Class 3 Permit Modification Request

Excavation of a New Shaft and Associated Connecting Drifts

**Waste Isolation Pilot Plant
Carlsbad, New Mexico**

WIPP Permit Number - NM4890139088-TSDF

Figure D-2-S#5
Spatial View of the WIPP Facility (with S#5)

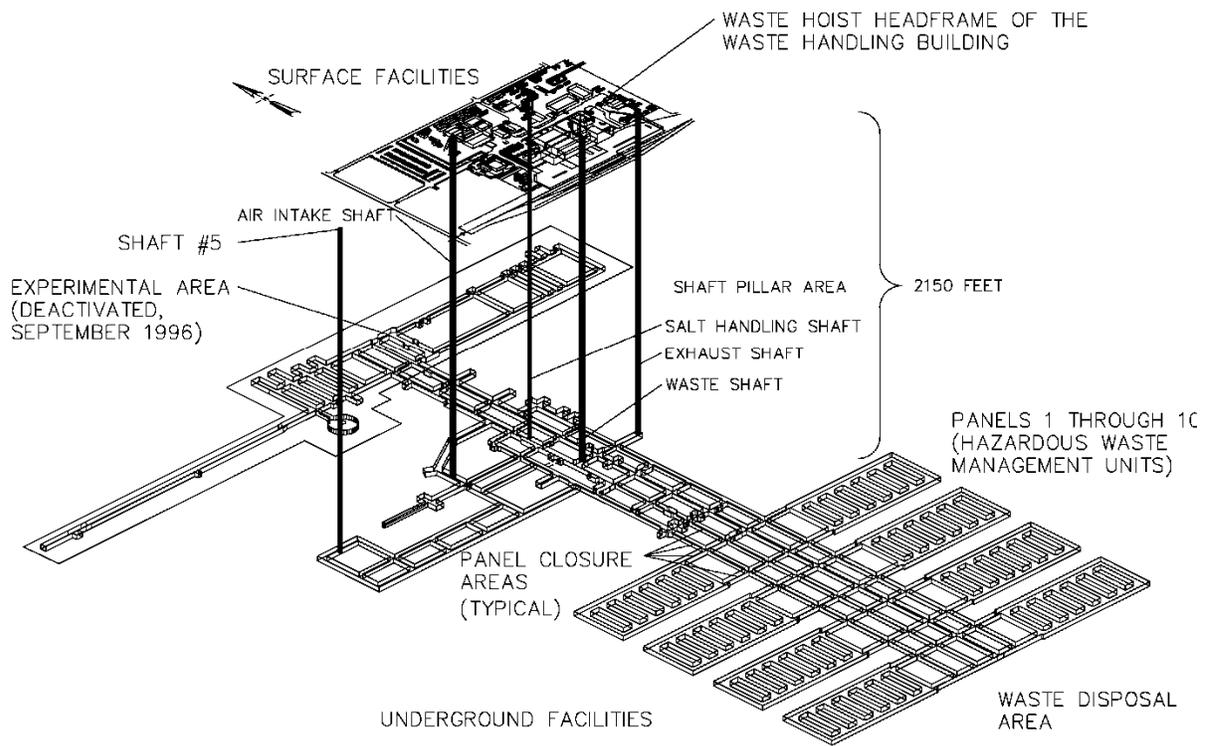
Attachment D, Figure D-2-S#5	The <i>Spatial View of the WIPP Facility (with S#5)</i> figure is being added to show the location of S#5 and the planned connecting drifts in relation to the existing underground facility. This change is needed to update the Permit with the information pertaining to S#5.

Figure D-3
WIPP Underground Facilities

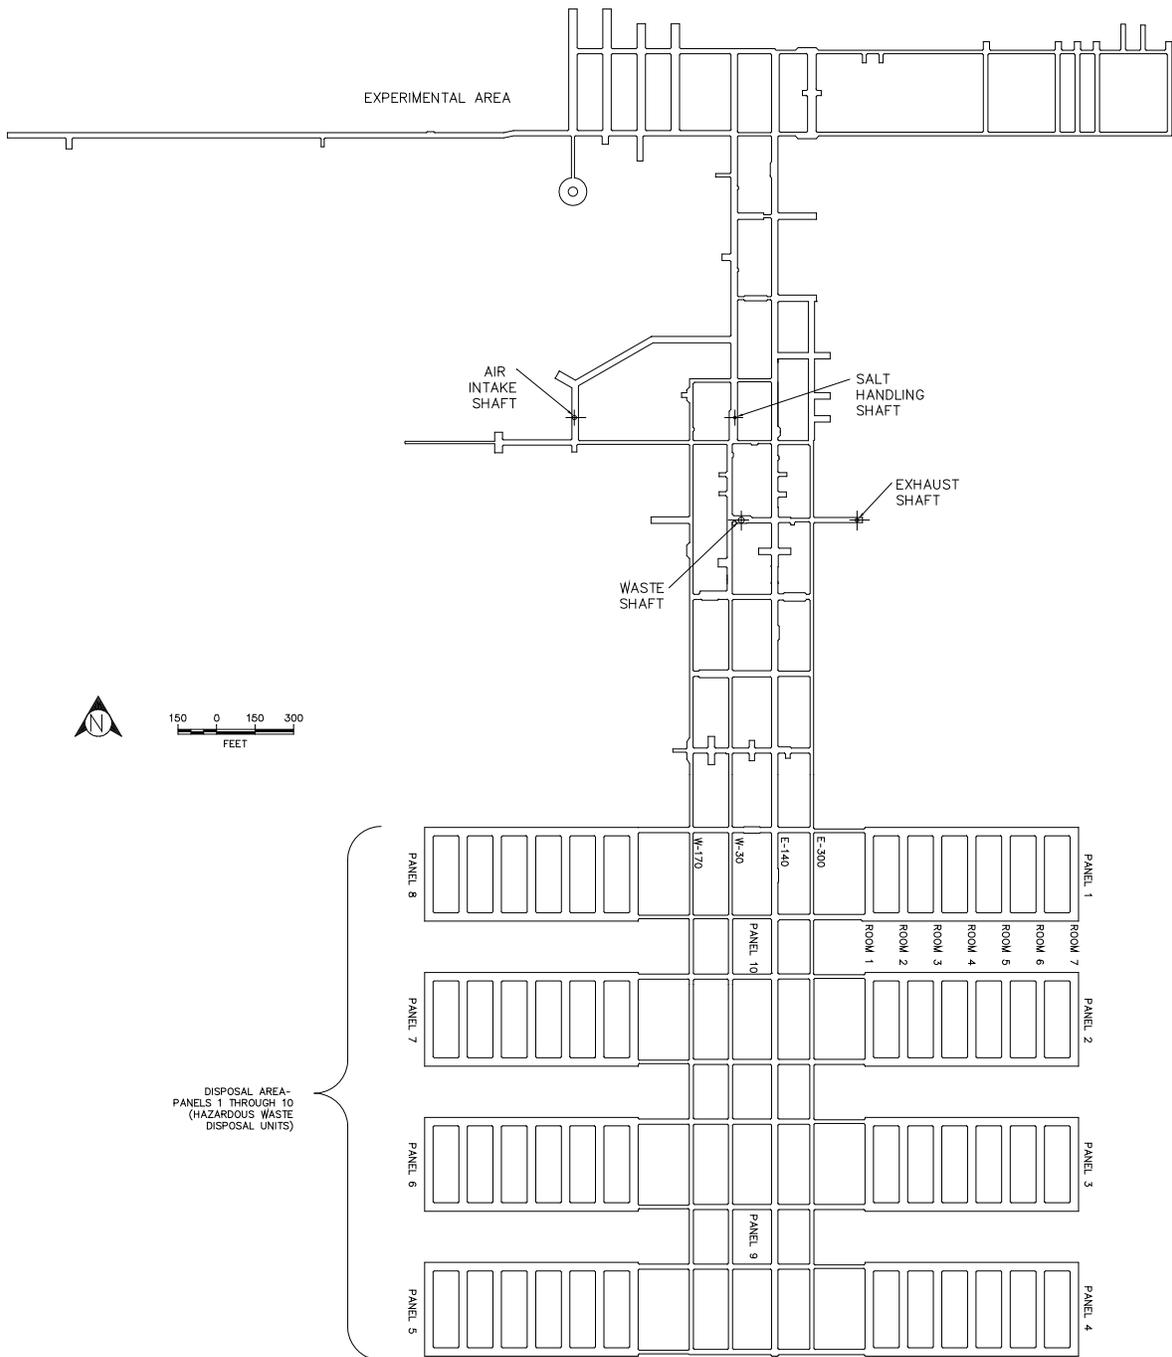
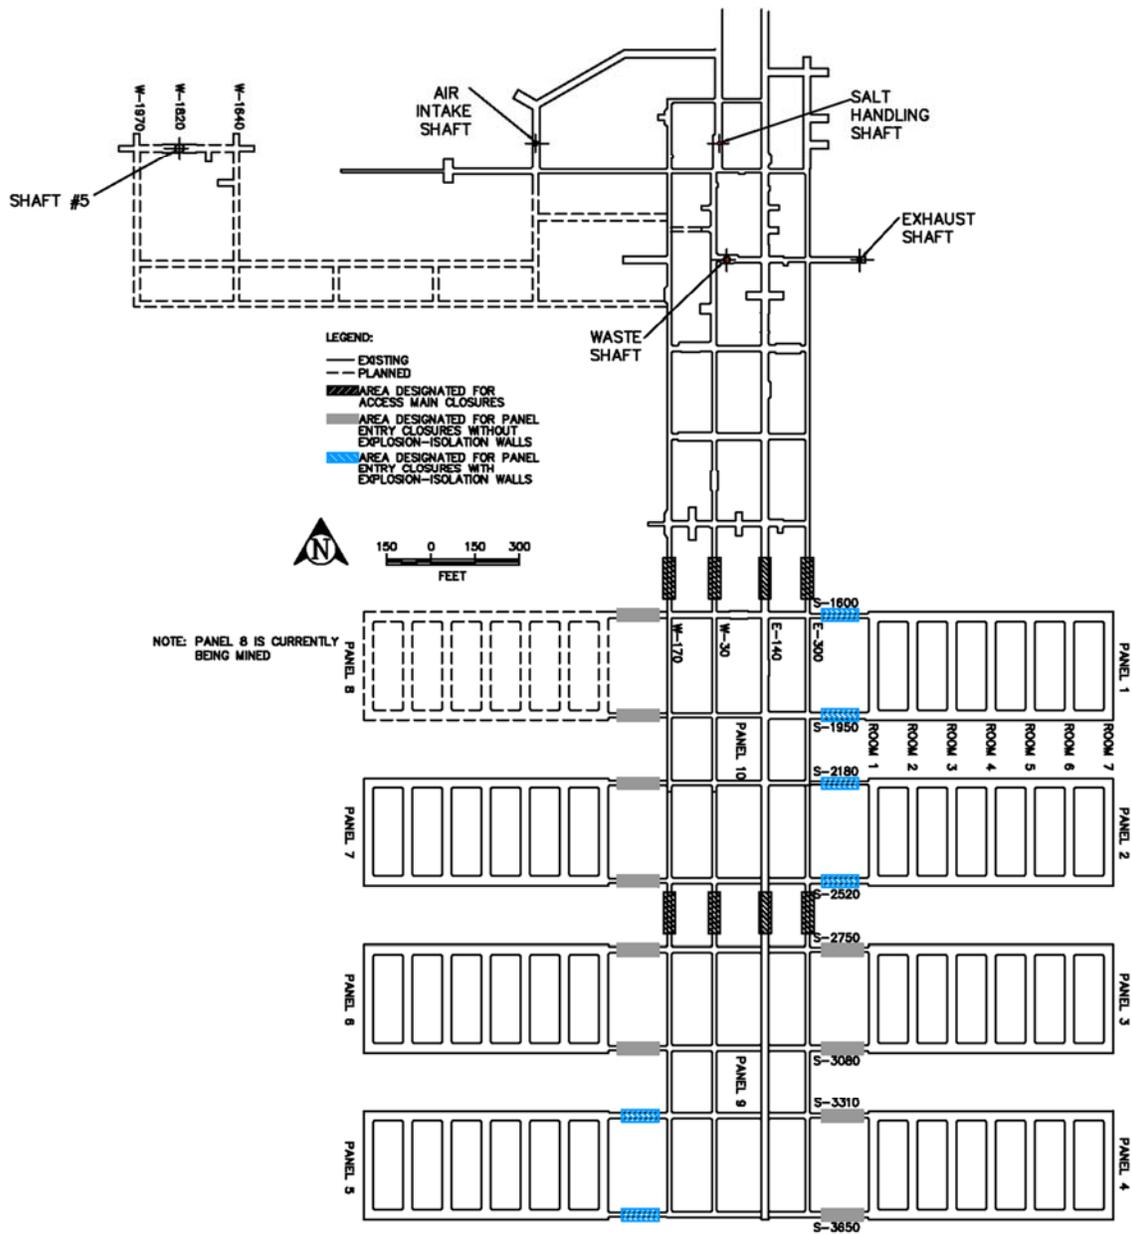
Permit Part/Section	Impact
Attachment D, Figure D-3	The <i>WIPP Underground Facilities</i> figure is being modified to show the location of S#5 along with the planned drifts to connect the shaft to the underground facility. This change is needed to update the Permit with the information pertaining to S#5.
Attachment D, Figure D-5-NFB	The <i>Fire-Water Distribution System with Building 416</i> figure is being replaced to show the fire-water loop extending to the S#5 area. This change is needed to update the Permit with the information pertaining to S#5.
Attachment D, Figure D-5-S#5	The <i>Fire-Water Distribution System (with S#5)</i> figure is being added to show the fire-water loop around the S#5 area. This change is needed to update the Permit with the information pertaining to S#5.
Attachment D, Figure D-7	The <i>Designated Underground Assembly Areas</i> figure is being modified to show the location of S#5 along with the planned drifts to connect the shaft to the underground facility. This change is needed to update the Permit with the information pertaining to S#5.

Figure D-5-S#5
Fire-Water Distribution System (with S#5)

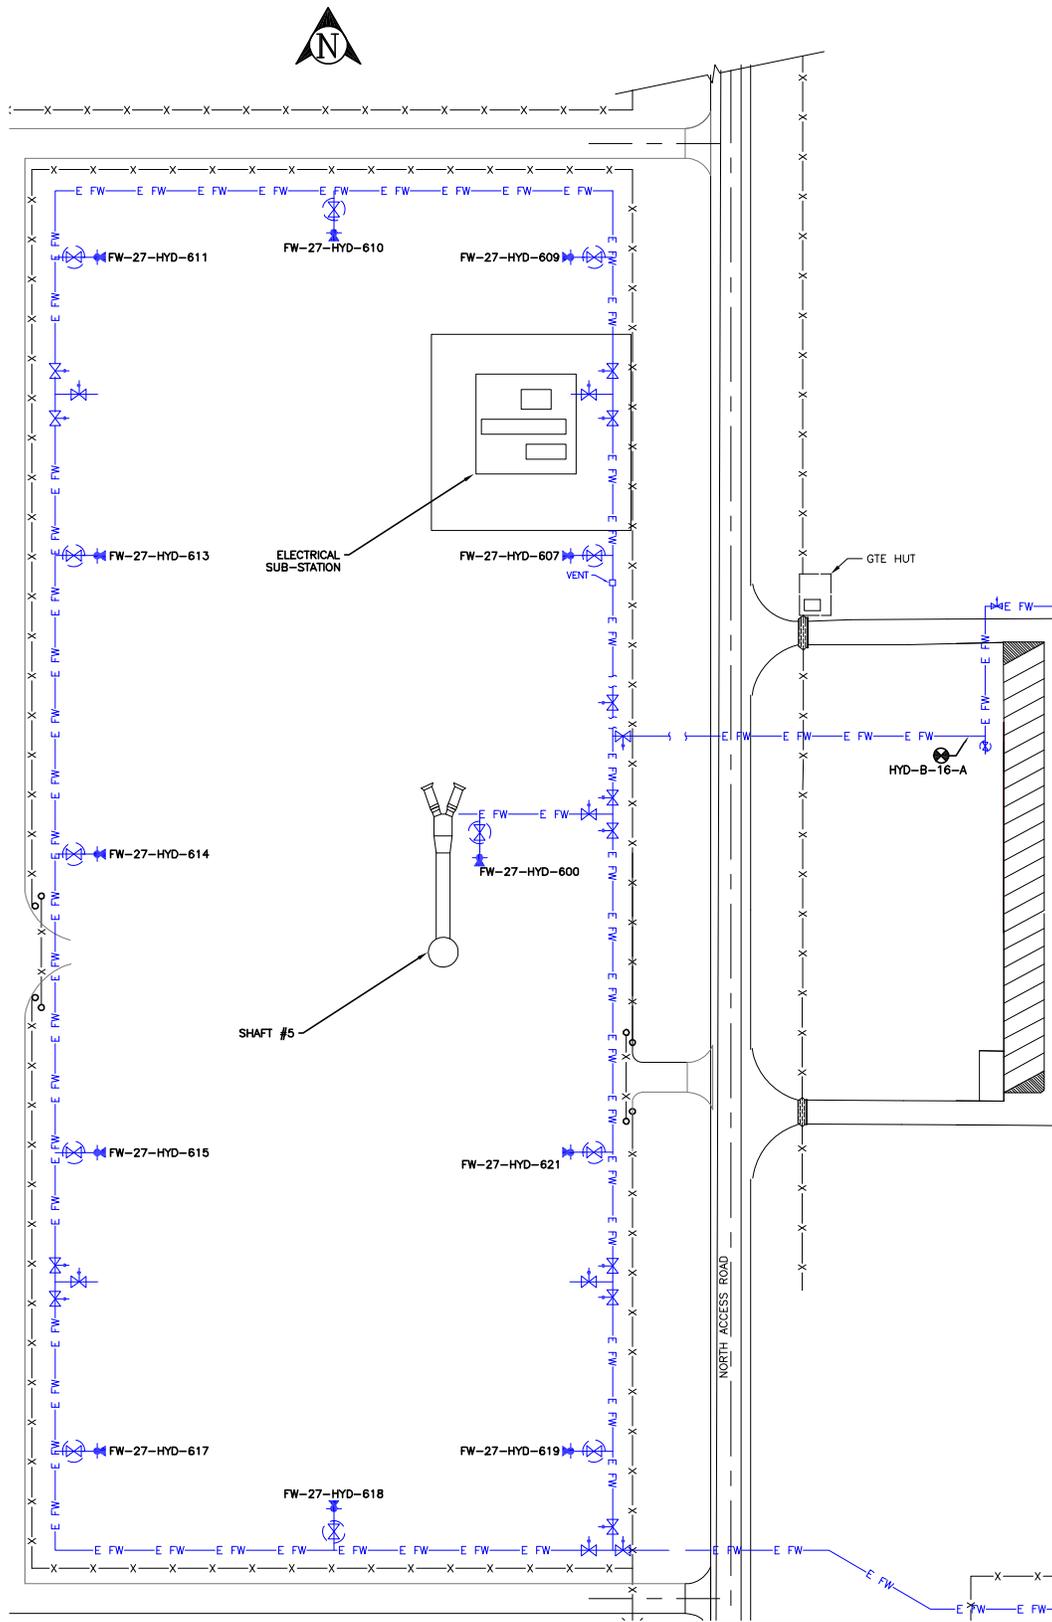
- One additional figure is being added to Permit Attachment D. Figure D-5-S#5, *Fire-Water Distribution System (with S#5)*, shows the fire-water loop and fire hydrants servicing S#5.

Attachment D, Figure D-5-S#5	Added new Figure D-5-S#5, <i>Fire-Water Distribution System (with S#5)</i> , after Figure D-5.
Attachment D, Figure D-7	Replaced Figure D-7, <i>Designated Underground Assembly Areas</i> , with new figure.
Attachment D, Figure D-8	Replaced Figure D-8, <i>WIPP Site Evacuation Routes</i> , with new figure.
Attachment G, <i>Introduction</i>	Deleted “the four” before shaft and added “for each shaft” after systems in first paragraph of the introduction.
Attachment G, Figure G-1	Replaced Figure G-1, <i>Location of Underground HWDUs and Anticipated Closure Locations</i> , with new figure.
Attachment G, Figure G-6	Replaced Figure G-6, <i>Approximate Locations of Boreholes in Relation to the WIPP Underground</i> , with new figure.

Figure D-8
WIPP Site Evacuation Routes

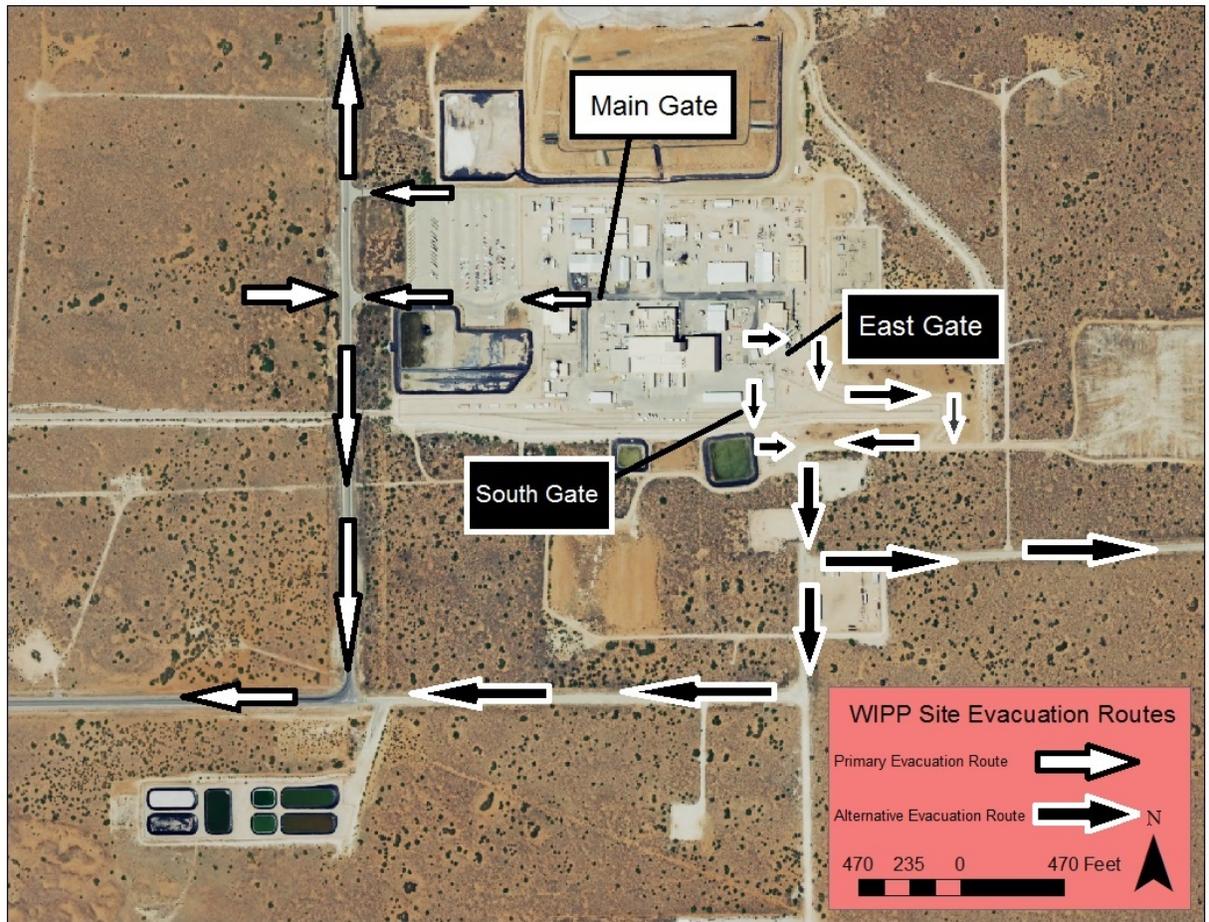
- Permit Attachment D, Figure D-8, *WIPP Site Evacuation Routes*, is being modified to show the evacuation route from the S#5 area on the west side of the North Access Road.

Attachment D, Figure D-8	The <i>WIPP Site Evacuation Routes</i> figure is being modified to show the evacuation routes from the S#5 area. This change is needed to update the Permit with the information pertaining to S#5.
Attachment G, <i>Introduction</i>	This section is being modified to show that the shaft seal systems apply to all shafts, not “the four” shafts as is currently stated. This change is needed to update the Permit with the information pertaining to S#5.
Attachment G, Figure G-1	The <i>Location of Underground HWDUs and Anticipated Closure Locations</i> figure is being modified to show the location of S#5 along with the planned drifts to connect the shaft to the underground facility. This change is needed to update the Permit with the information pertaining to S#5.
Attachment G, Figure G-6	The <i>Approximate Locations of Boreholes in Relation to the WIPP Underground</i> figure is being modified to show the location of S#5 along with the planned drifts to connect the shaft to the underground facility. This change is needed to update the Permit with the information pertaining to S#5.
